2021 NEW BUILDING FOR:  
**WALSER TOYOTA**  
4401 AMERICAN BLVD  
BLOOMINGTON, MINNESOTA

SITE PLAN

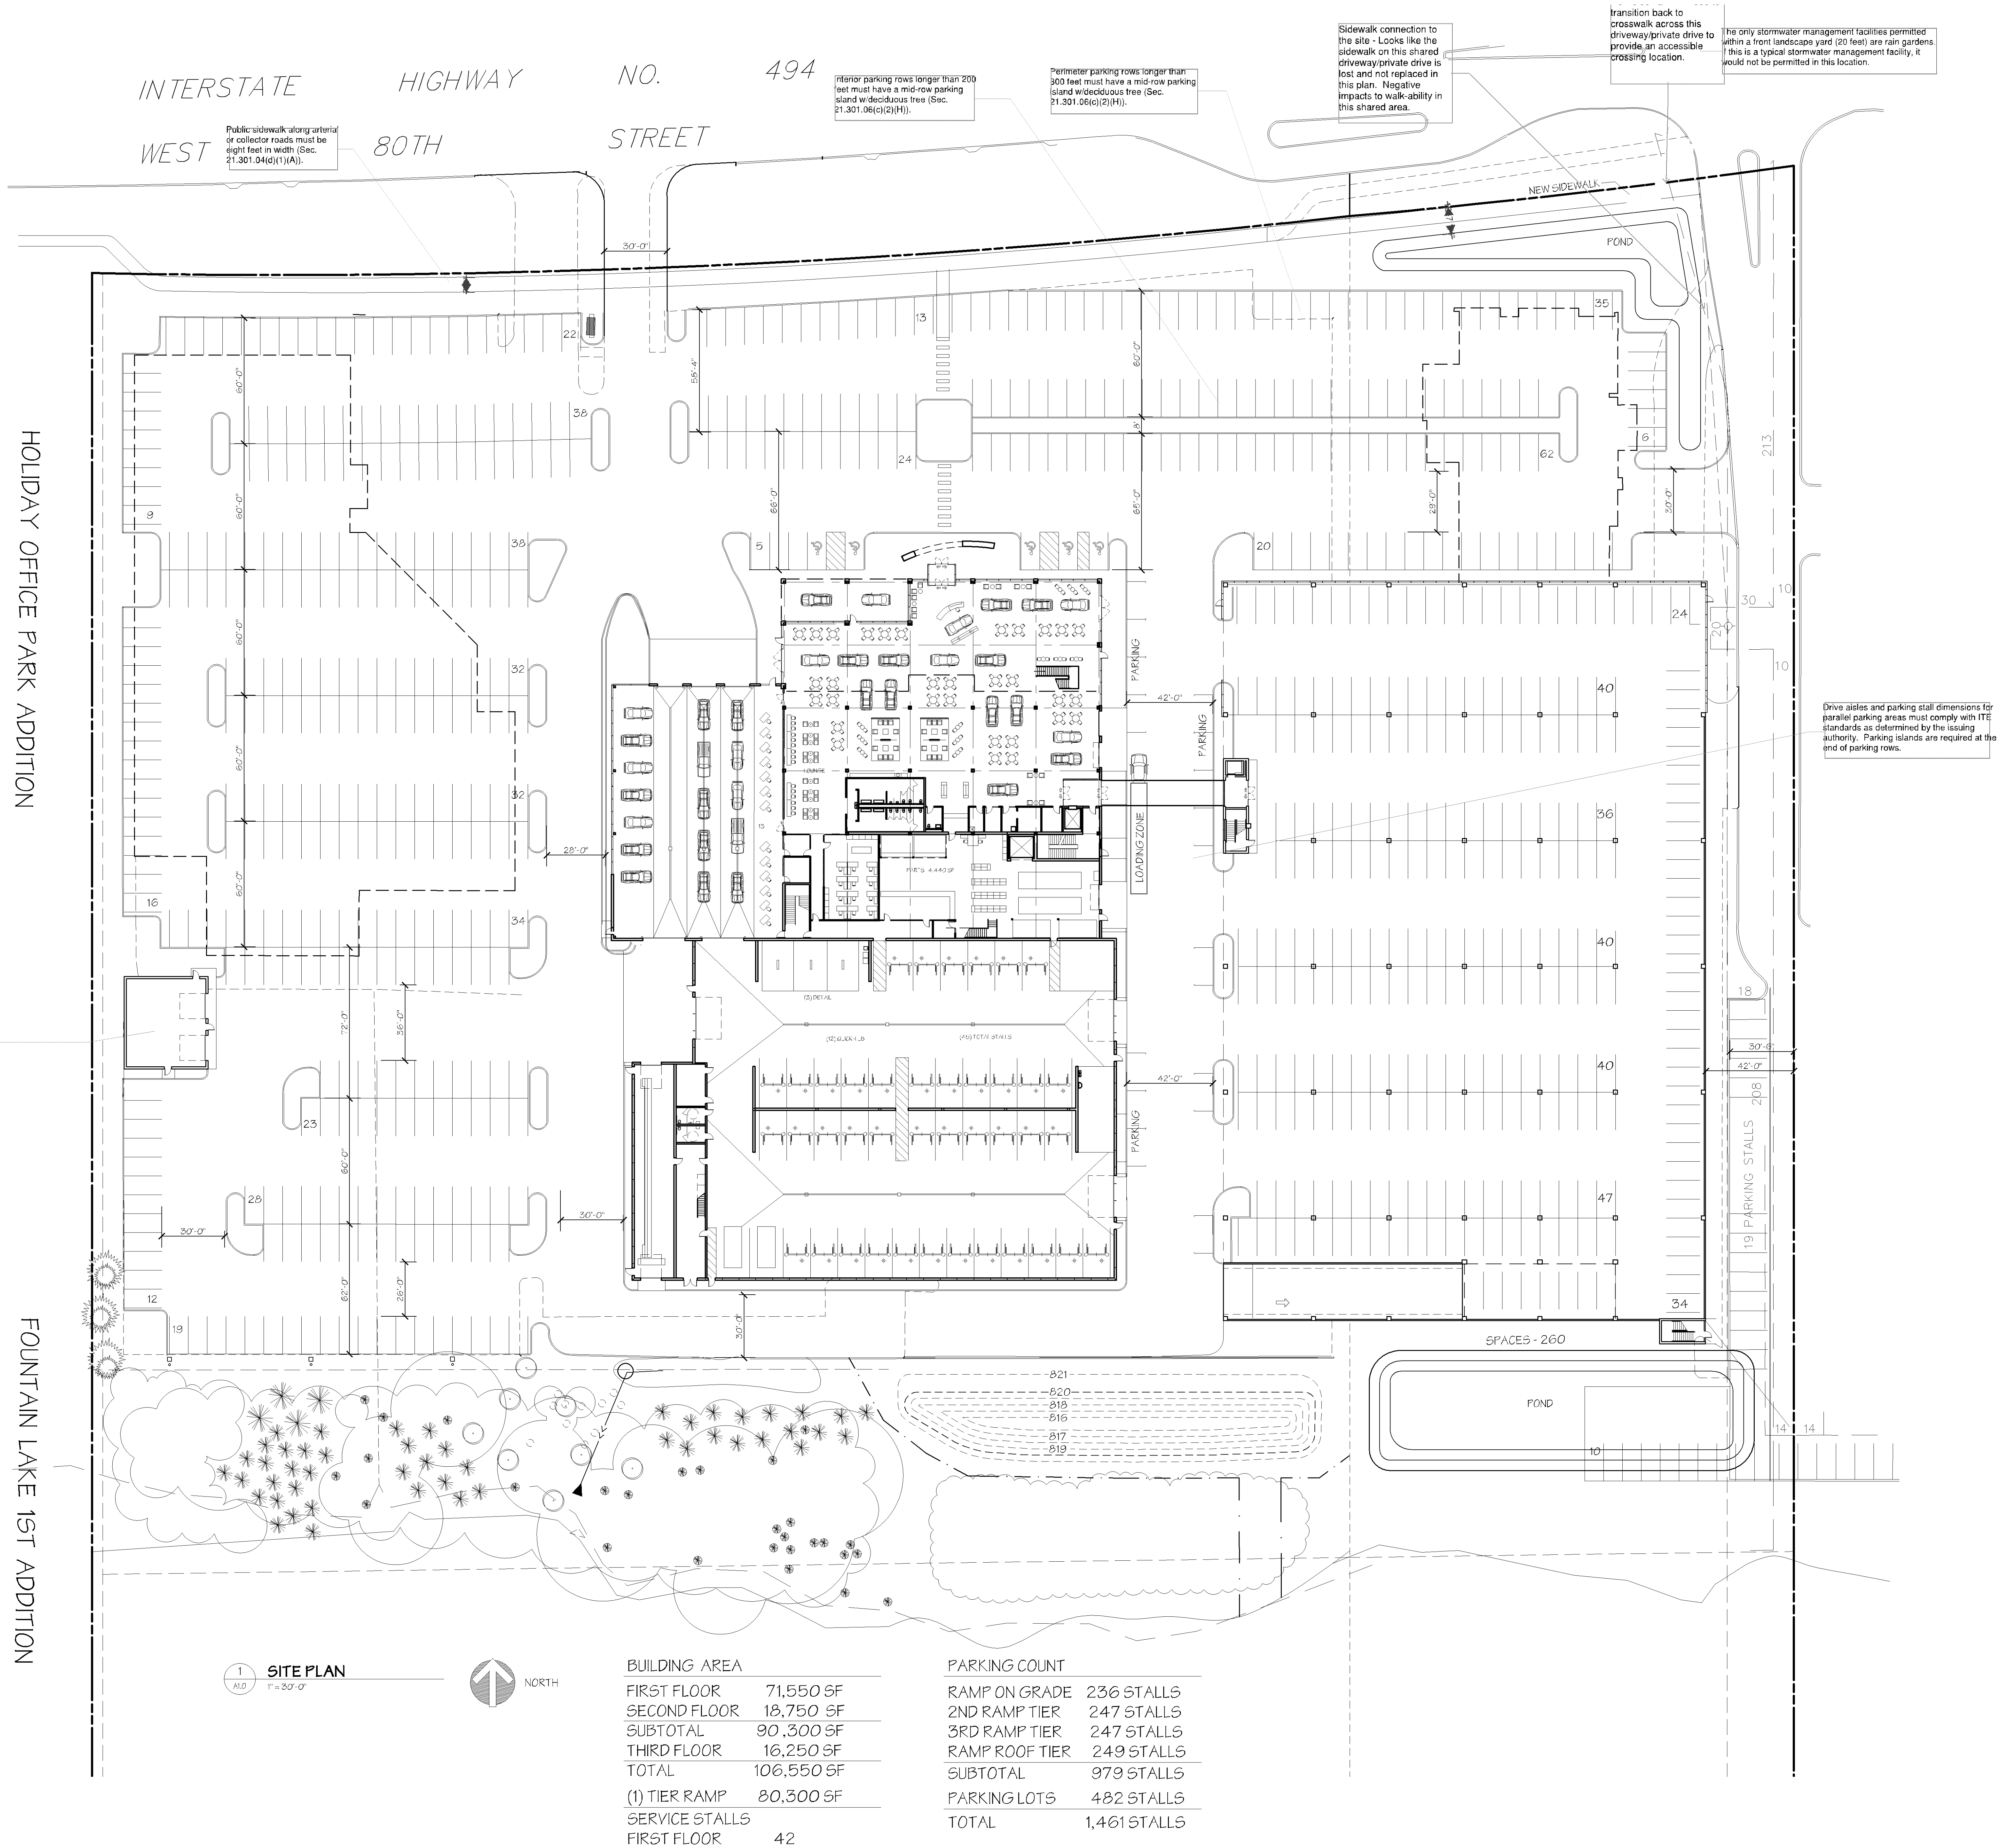
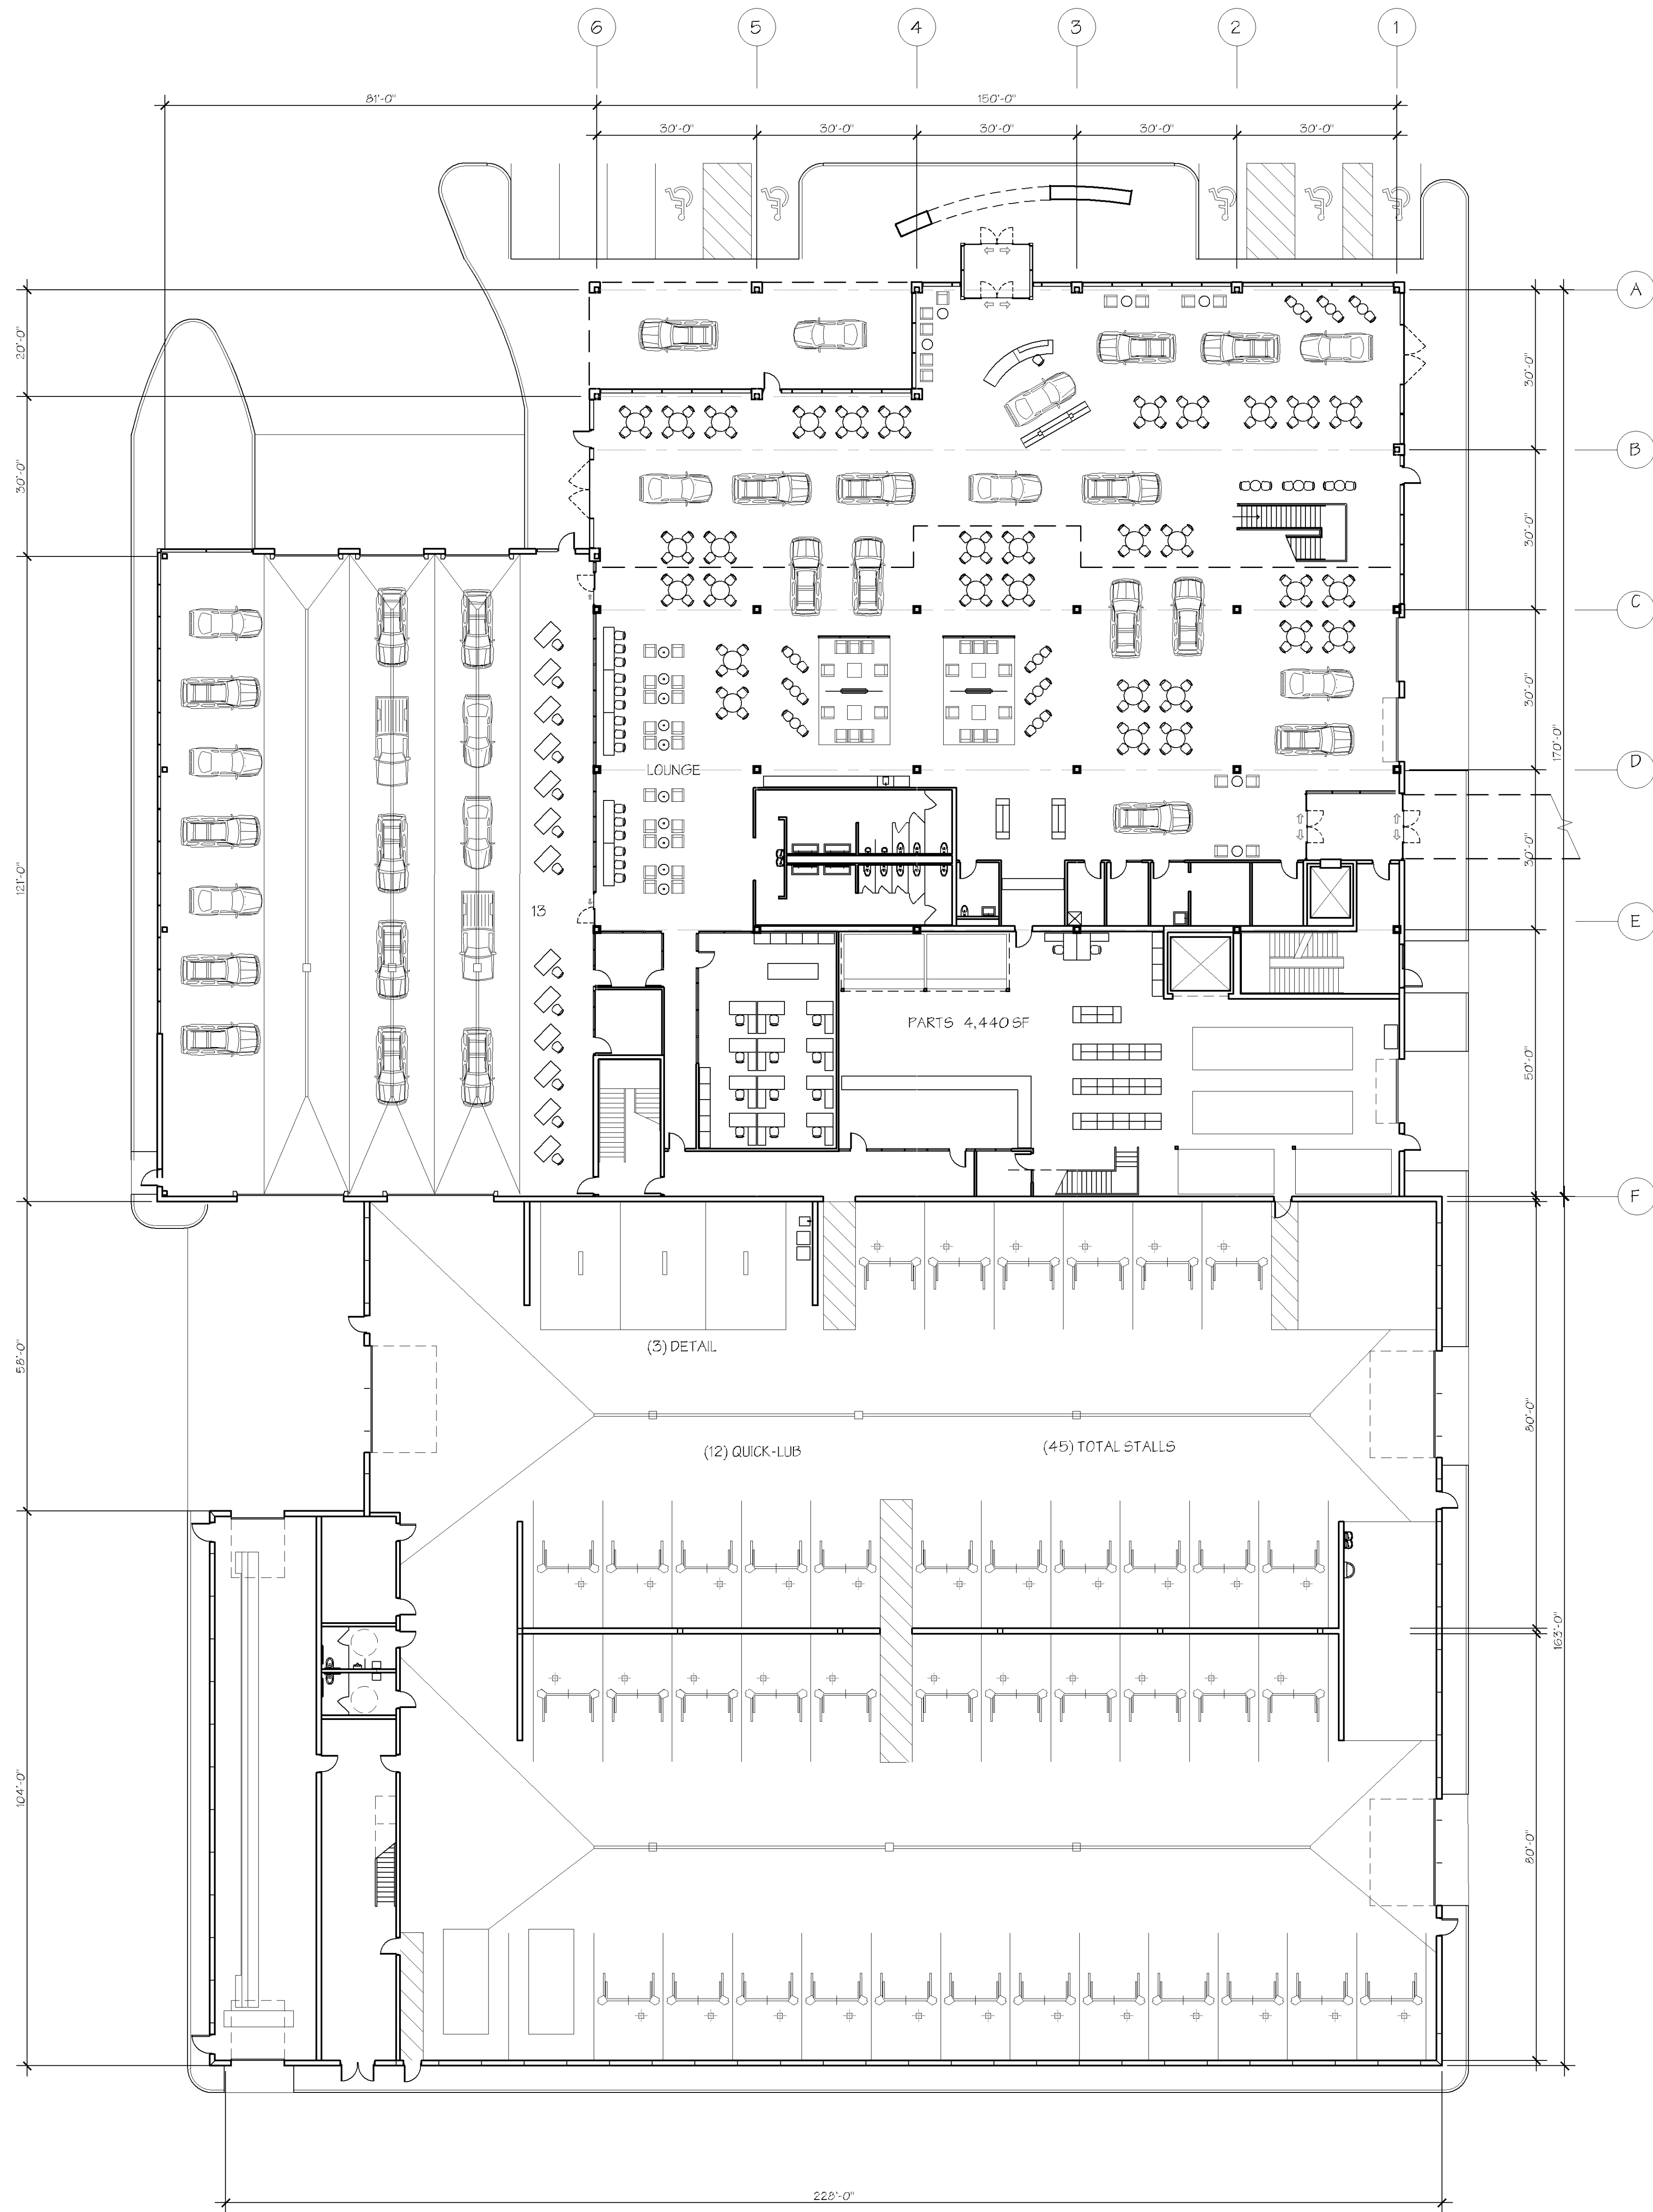
roperty shall be adequately  
emergency response.

Fire alarm and annunciator panels and  
Knox box locations to be determined  
by the Fire Prevention Division.

Must meet 2020 MN  
State Building Code

Must meet 2020 MN  
Accessibility Code.

Provide a detailed code  
analysis with the plans.

SAC review by MET  
Council will be required.

Separate permit and review by MN  
State Elevator inspector for elevators,  
escalators and moving walkways.

For all Plumbing plan reviews  
with job valuations over  
\$50,000: The plumbing plans  
must be submitted to the  
State of MN for review. A  
Plumbing permit is also  
required to be submitted to  
the City of Bloomington -  
Building and Inspections.

Detached trash and recycling  
storage is not permitted at  
commercial sites (Sec.  
21.301.17(c)(2)).

Hydrant coverage shall be provided  
within 50' of the FDC and within  
150' of all portions of the structure.

A minimum 13'6" clearance below the  
skyway between the building and  
parking ramp shall be provided.

Provide adequate turning radius using  
Ladder 3 specs for all emergency vehicle  
access lanes.

Parking ramp dry downslope hose  
valves shall be located within 130'  
of all areas of the ramp.

Emergency responder radio coverage meeting  
the requirements of appendix L in the 2015  
MSFC shall be provided throughout the  
property and within the structures.

At least one lock box will be required  
for the building(s).

The parking ramp may be required to  
be sprinklered if there is obstructions  
and/or if the ramp is considered  
enclosed per the building code.
